OFFICIAL STAR CLASS MEASUREMENT CERTIFICATE

Report from International Measurement Committee

Star No. 326033

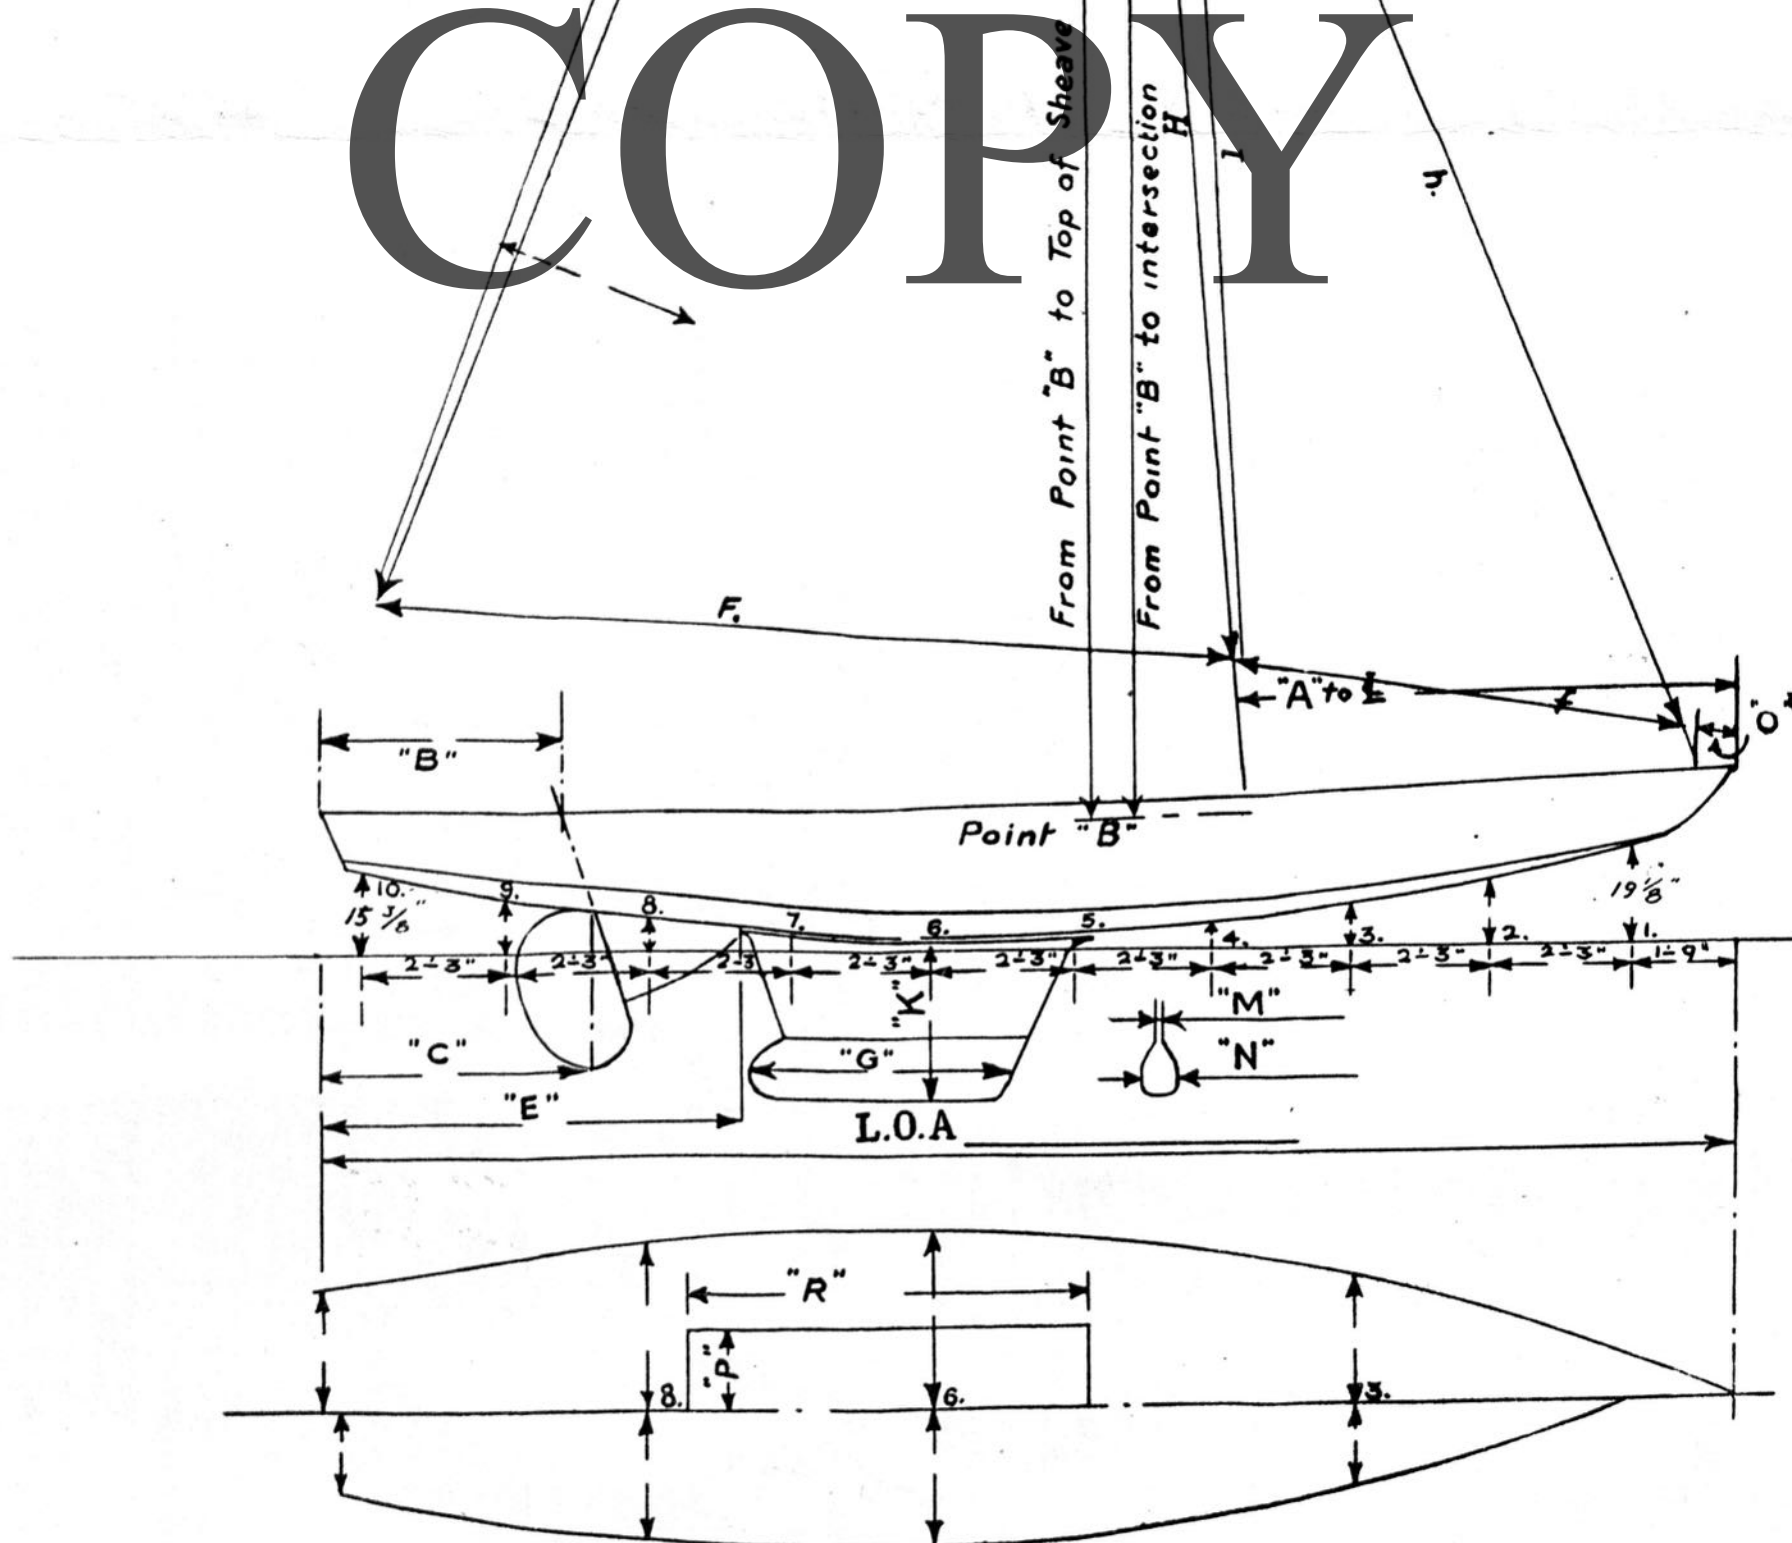
SKES DEPTH MEASURES $17\frac{1}{4}$ " - MAXIMUM IS 17"

The Sky depth ~~measured~~ on star #3266 has been fixed and now measures $16\frac{7}{8}$ "
